July 2007 AcquiSuite Firmware changes.

Firmware for the A8812 and A8811 released after July of 2007, will have a number of substantial changes. Users should be aware of these changes and how these may impact any custom applications that may have been developed. Although great care has been taken to maintain the previous feature set, users should test the firmware update prior to deploying this firmware on production equipment.

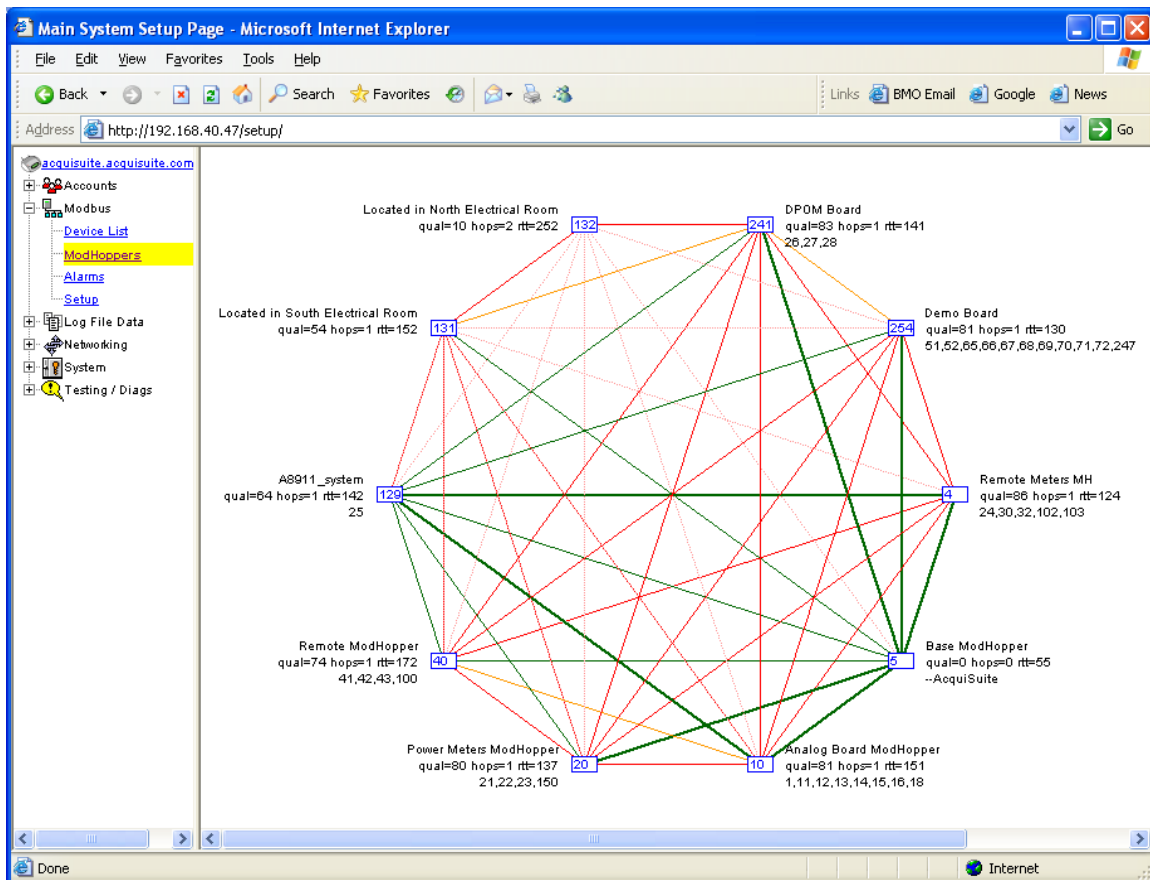
When web page or xml requests are serviced, the data cache age is evaluated. Web pages with cached data older than 10 seconds will show “(cached)” to the left of the device status on the top of each page. XML data now includes a tag “<age units="seconds">22</age>” that will report the age of the data, in seconds. Users with custom xml applications may need to adjust the URL used to query data from the AcquiSuite.
